Re:	Initial Submission Review	Blue Eagle Logistics Park - Master Plan
	Application Number:	DA-2375-00
	Case Numbers:	2024-7001-00

PLANNING DEPARTMENT COMMENTS

Context Map

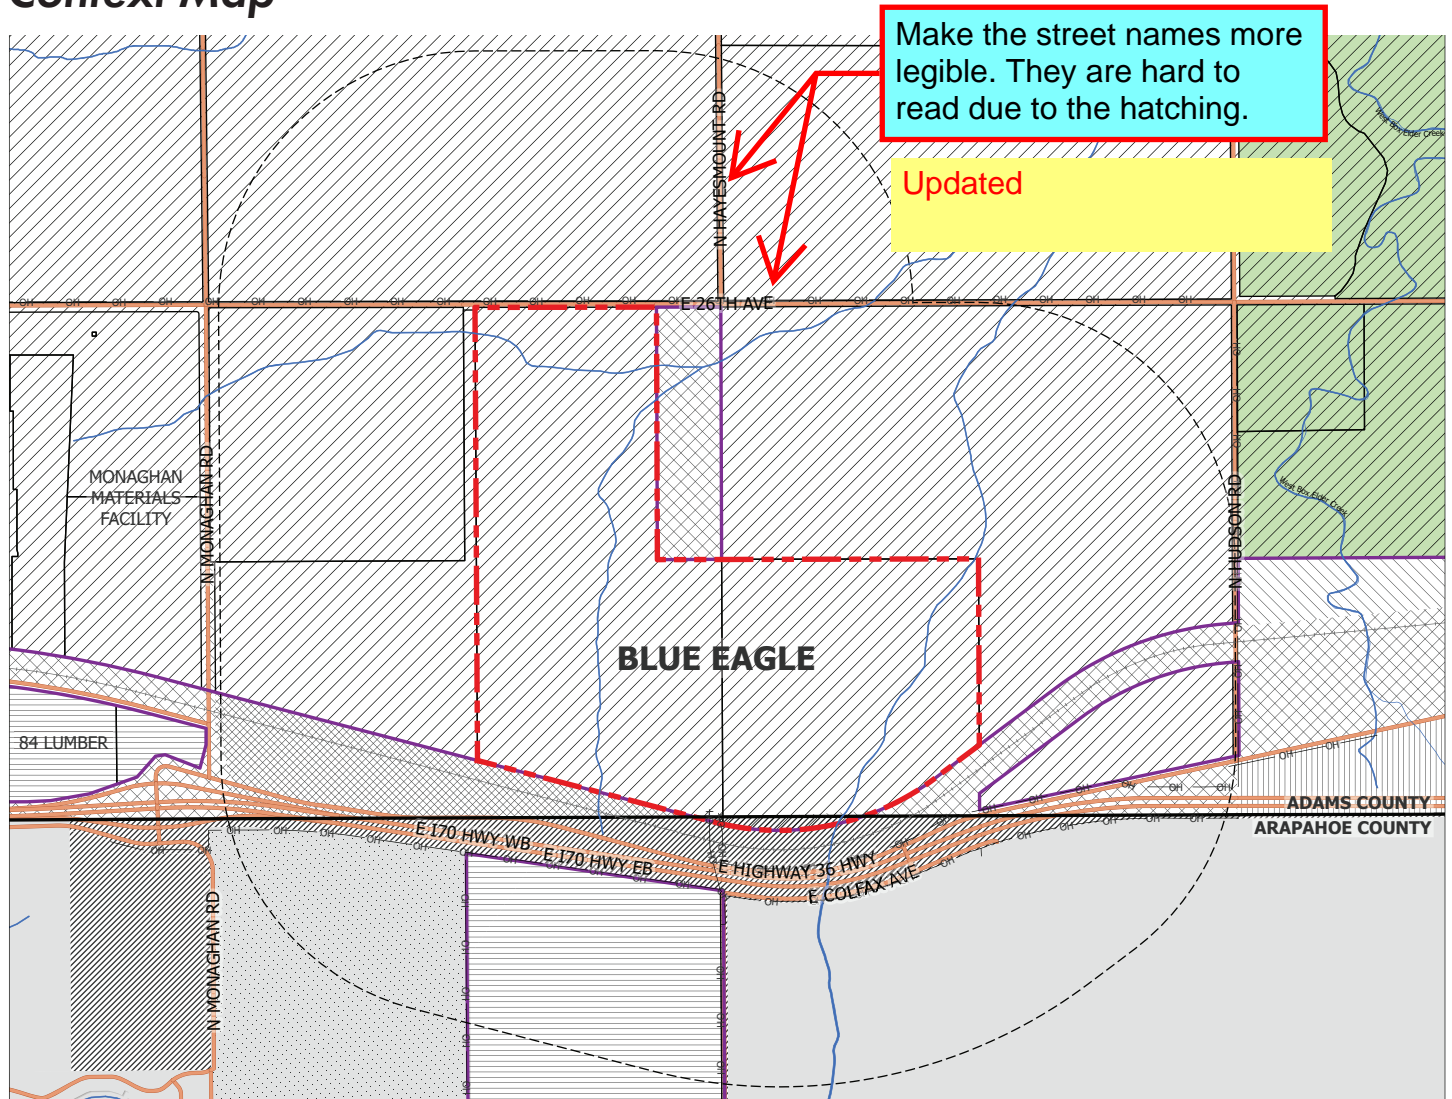
- 3A. Label the zoning on the map. Please add all the zoning districts to the map (I-1, MU-A, A-2 County, A-3 County, C-1 A-1 County, MU, and PUD). *Updated.*

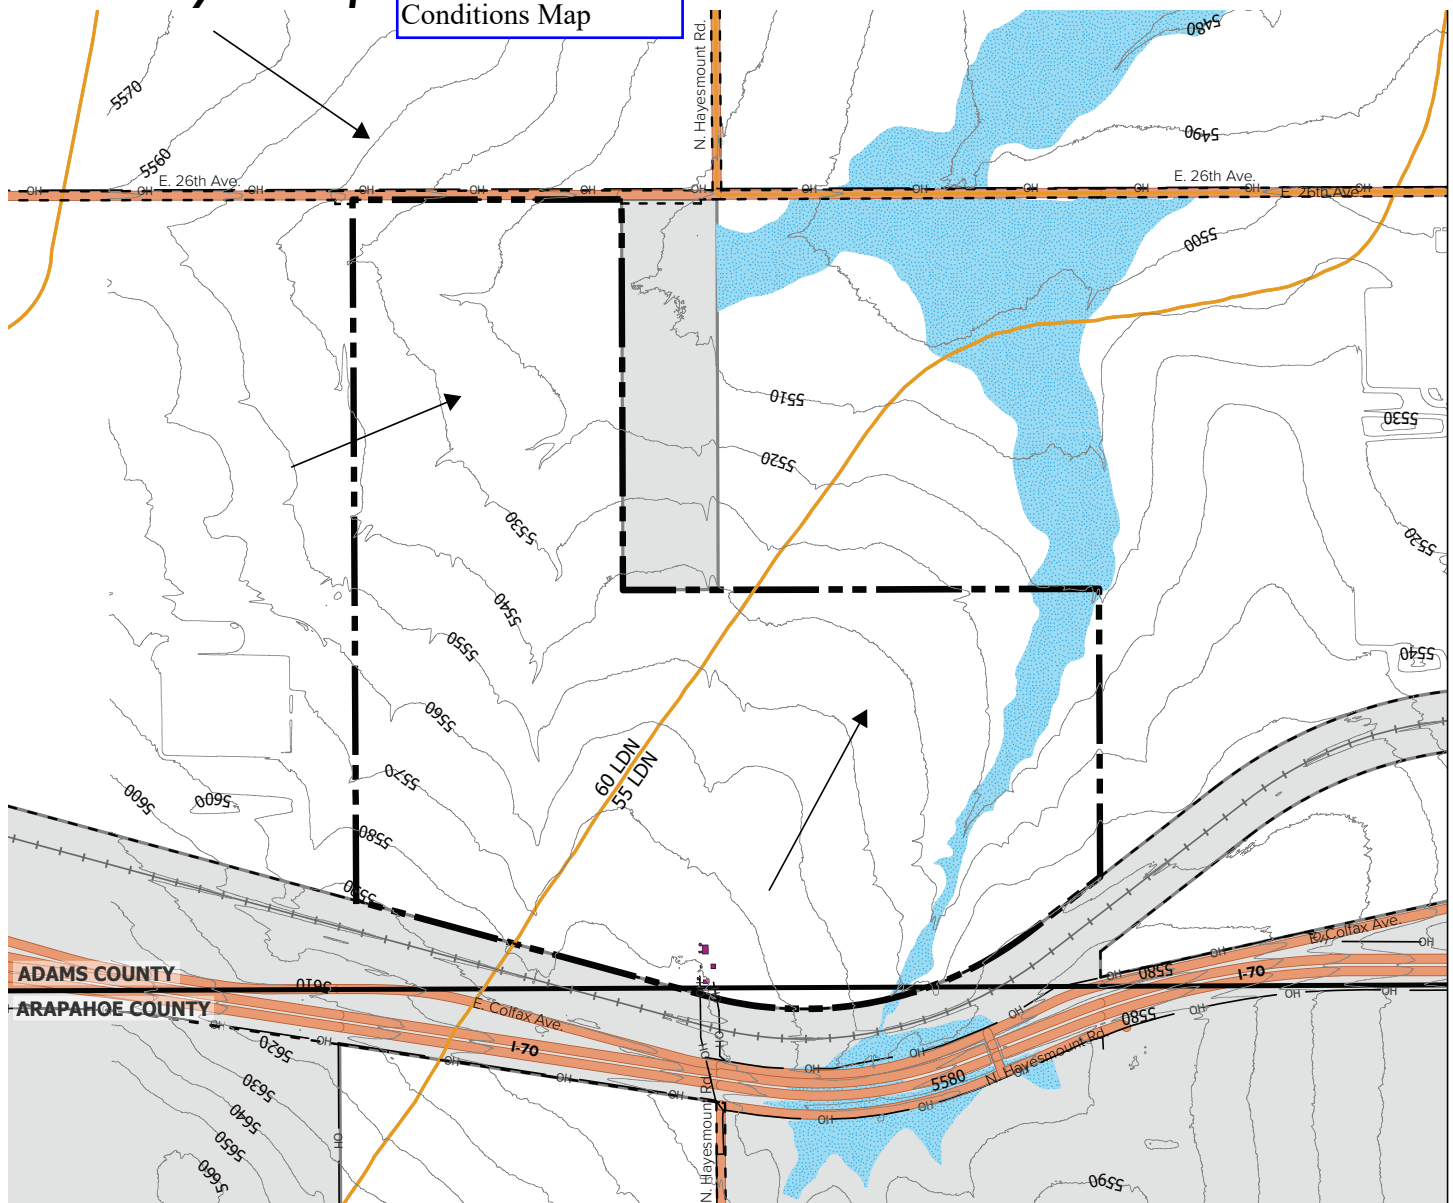
Missing answer for # 6
Development Impacts
on Existing site
Conditions

Please change the title from Site Analysis Map to Existing Conditions Map

Please add airport overlay district boundaries

Updated

Natural Features Map

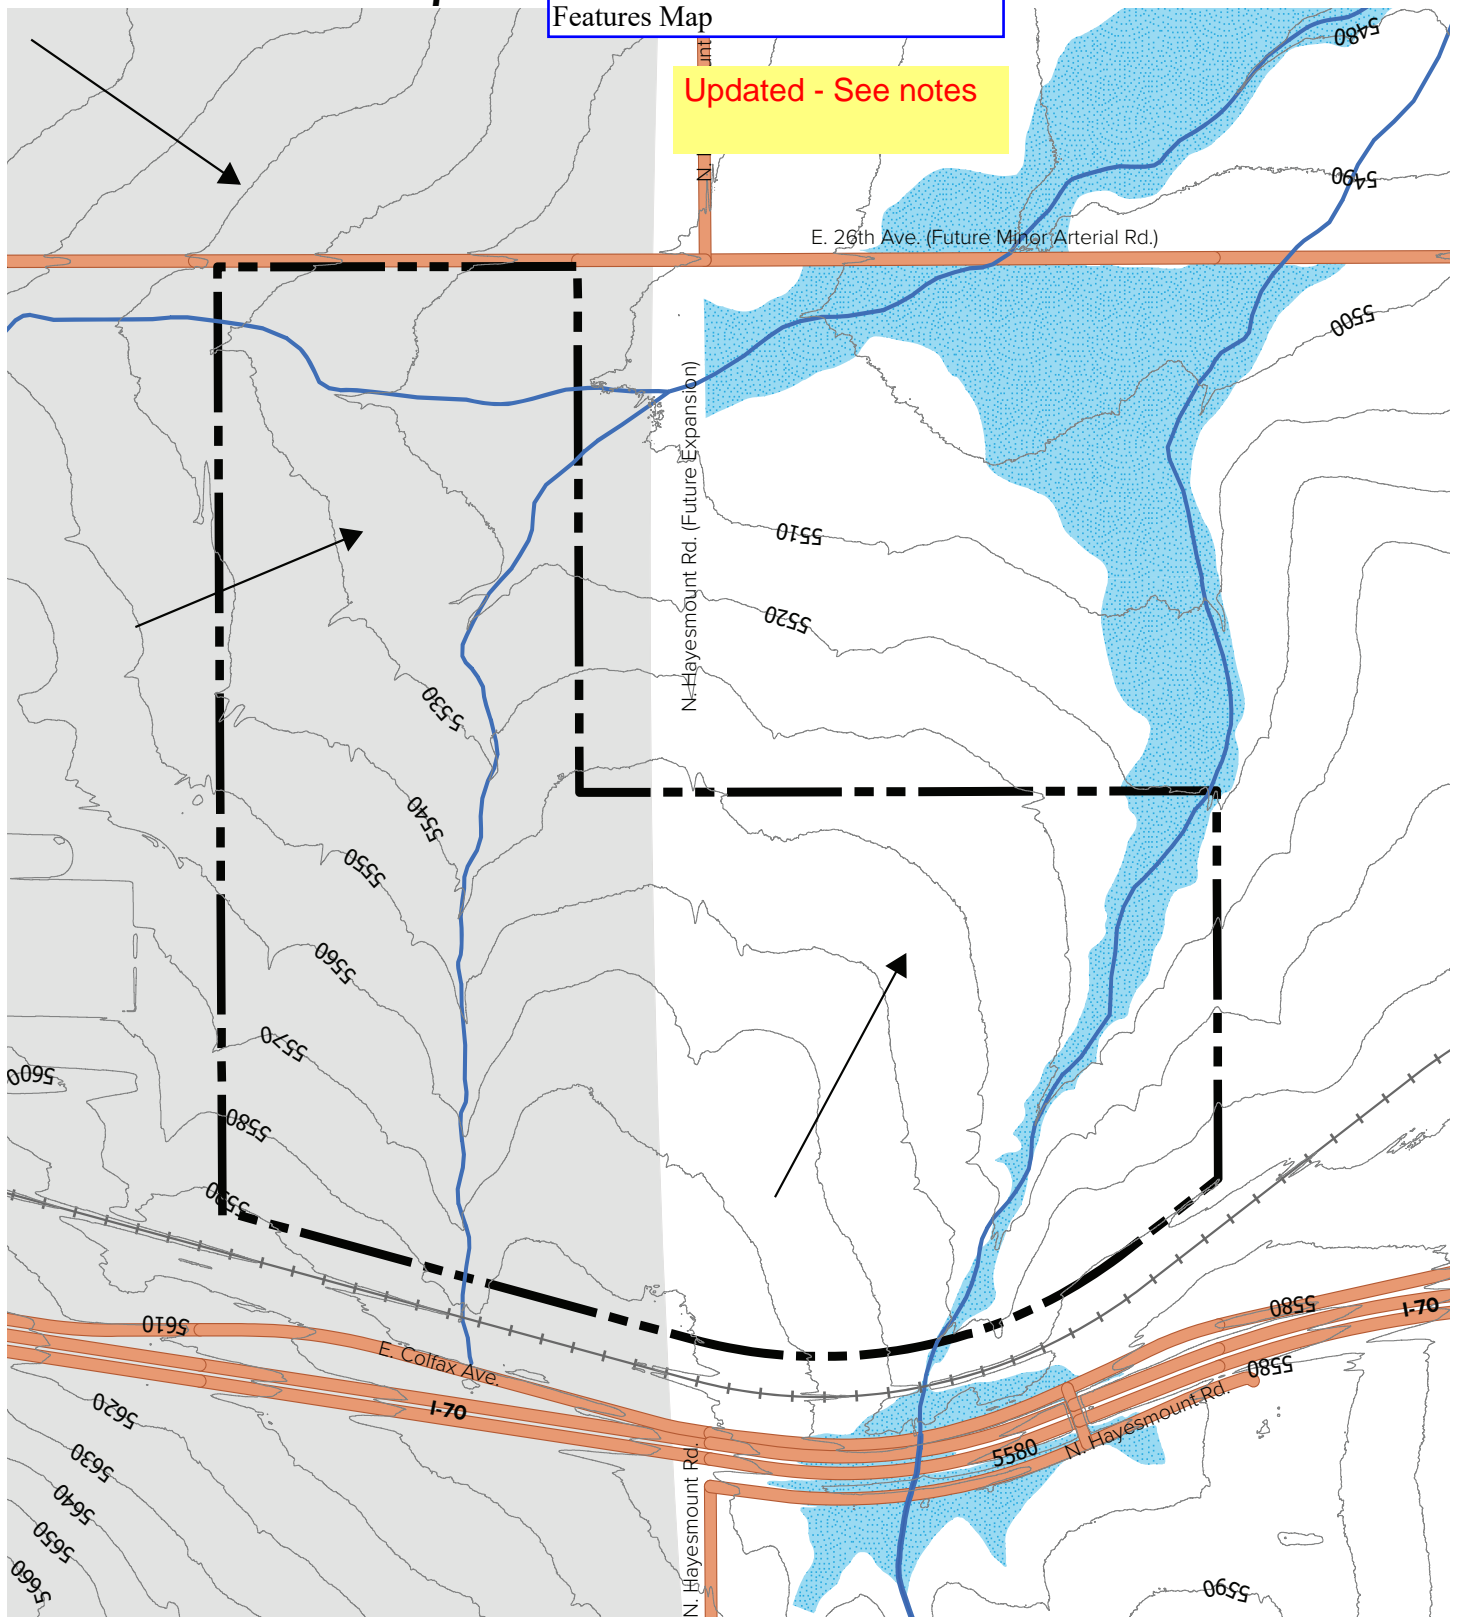
Please add Wildlife habitat as identified by the Colorado Division of Wildlife is required in the Natural Features Map

Updated - See notes

Land Use Map

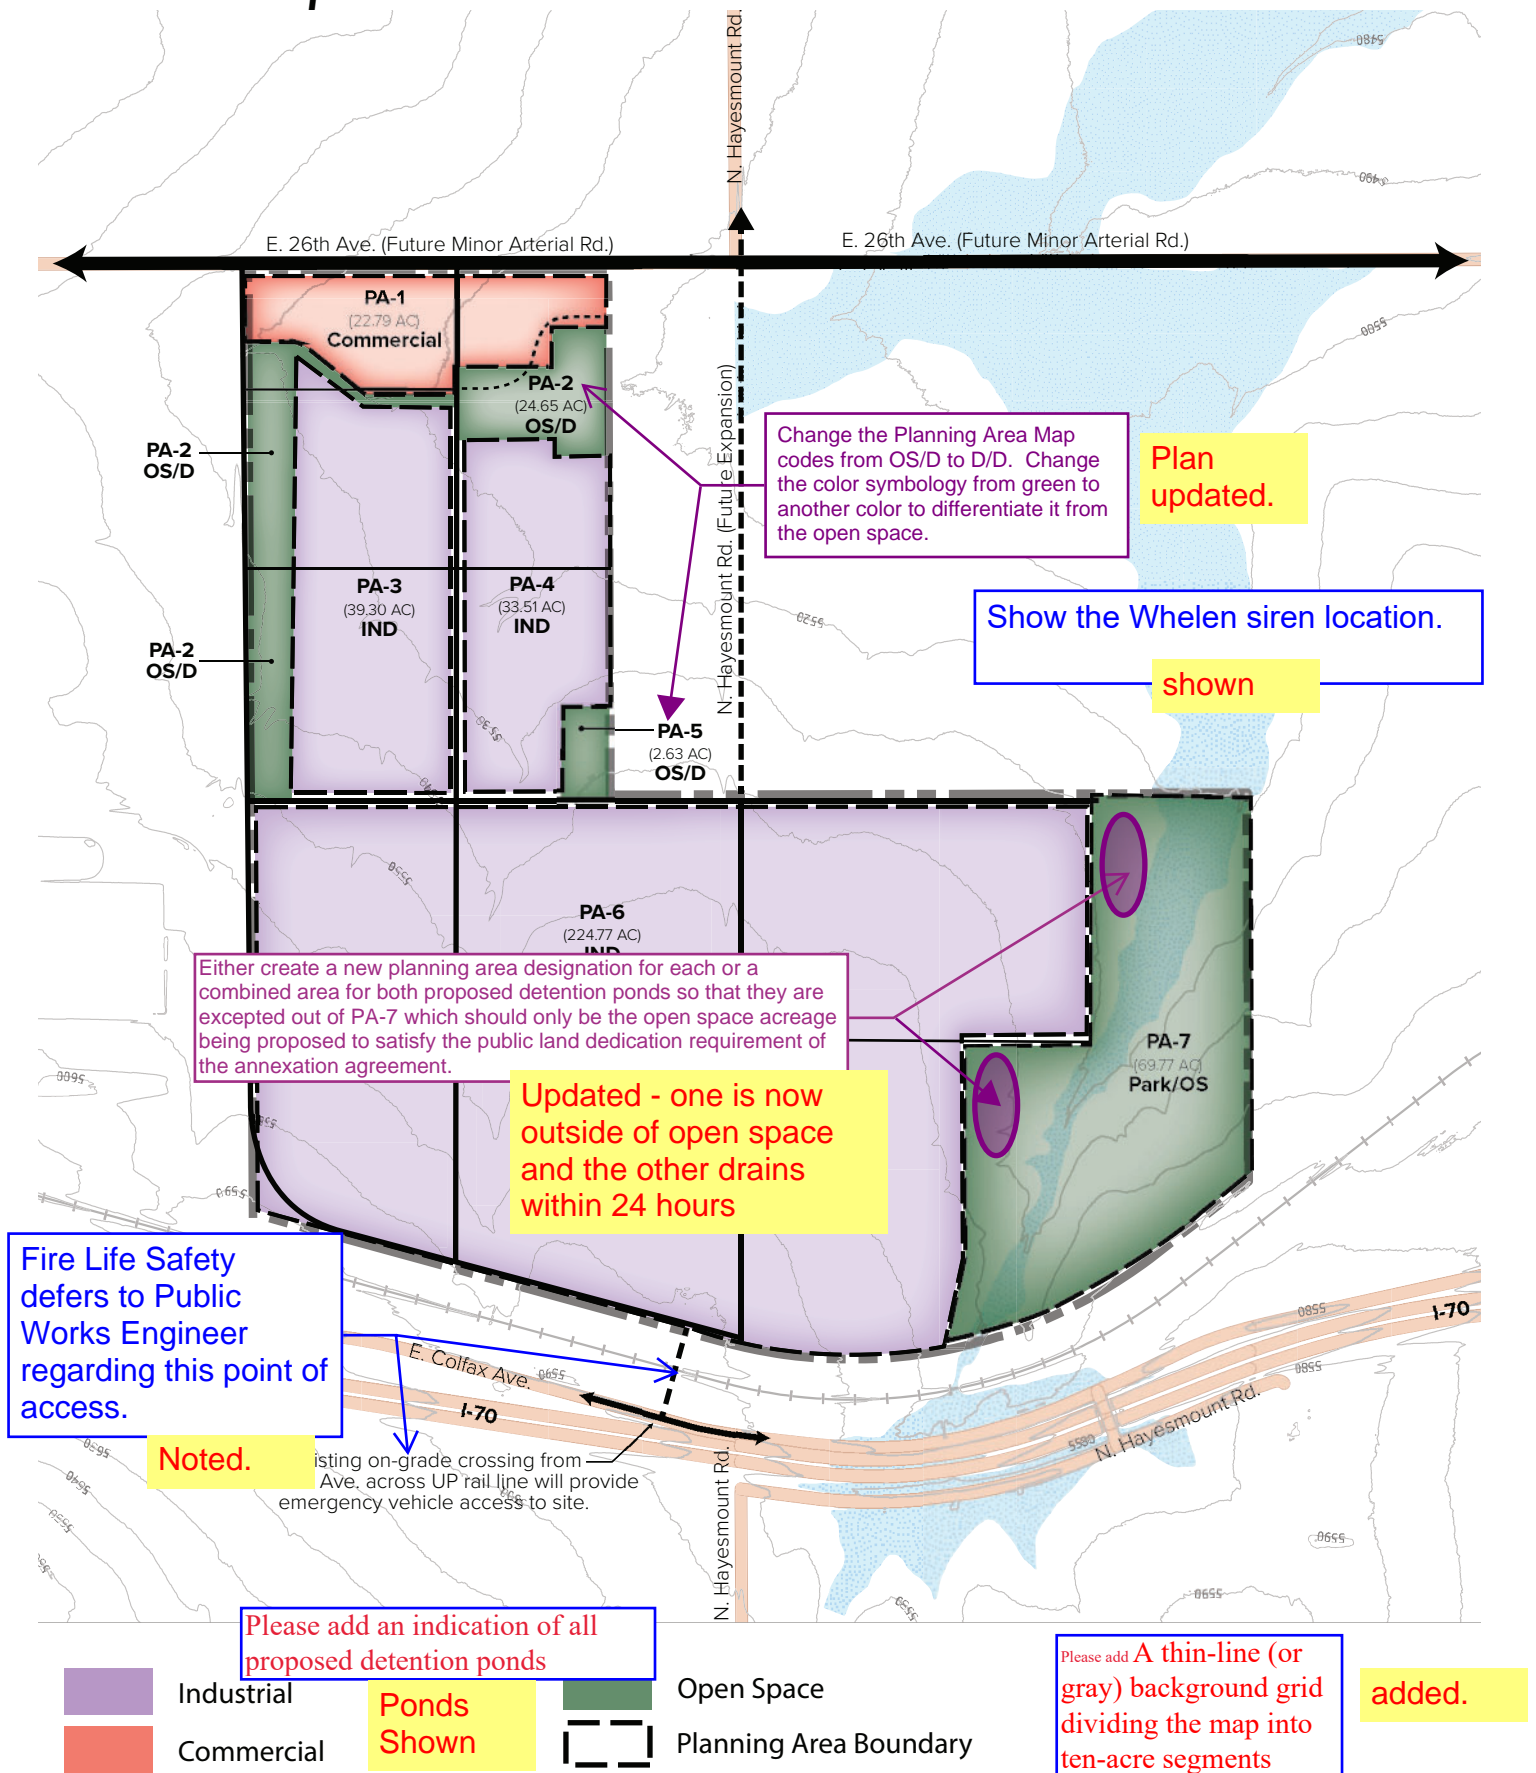
Show the 10' x 10' Whelen siren land dedication.

Open Space Plan

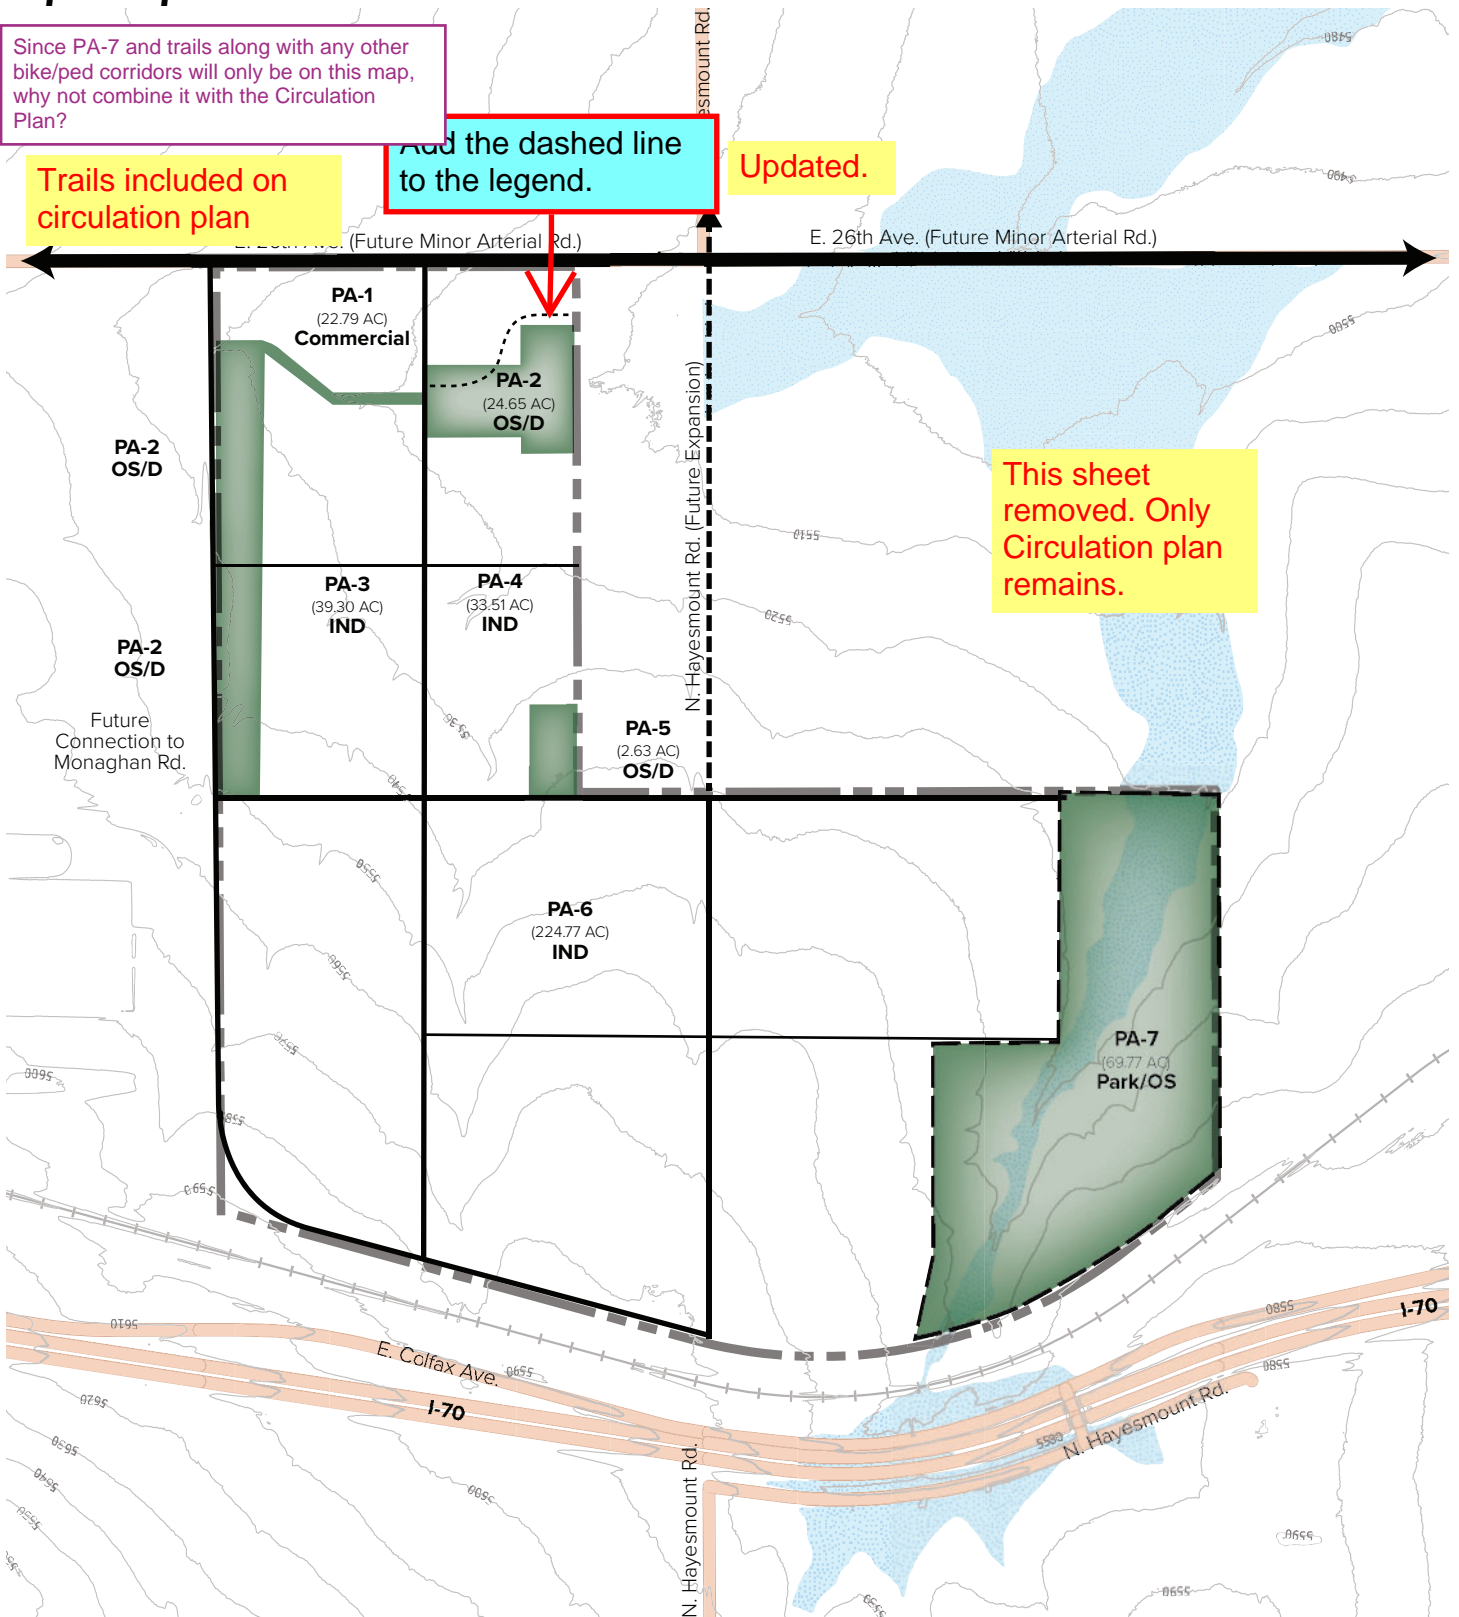
Since PA-7 and trails along with any other bike/ped corridors will only be on this map, why not combine it with the Circulation Plan?

Add the dashed line to the legend.

Please show drainage ponds and major drainage facilities

Trails included on circulation plan

This sheet removed. Only Circulation plan remains.

Section for all Internal Roads

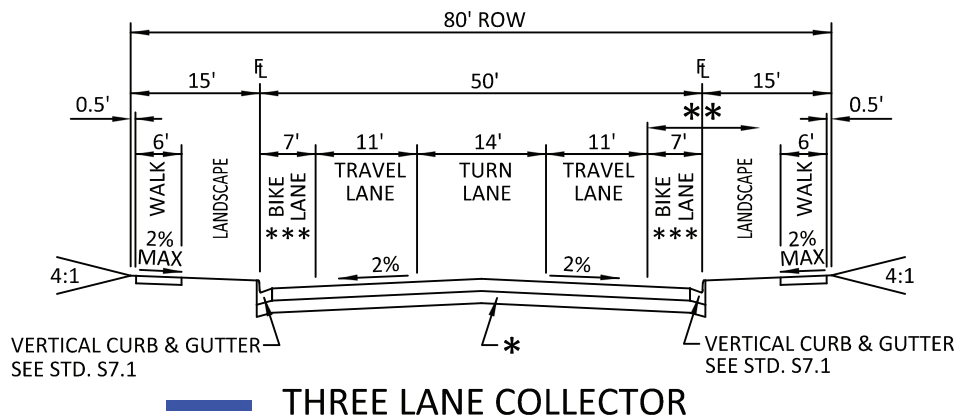
Ensure this section matches what is propose on the PIP.

Sections have been removed from this TAB.
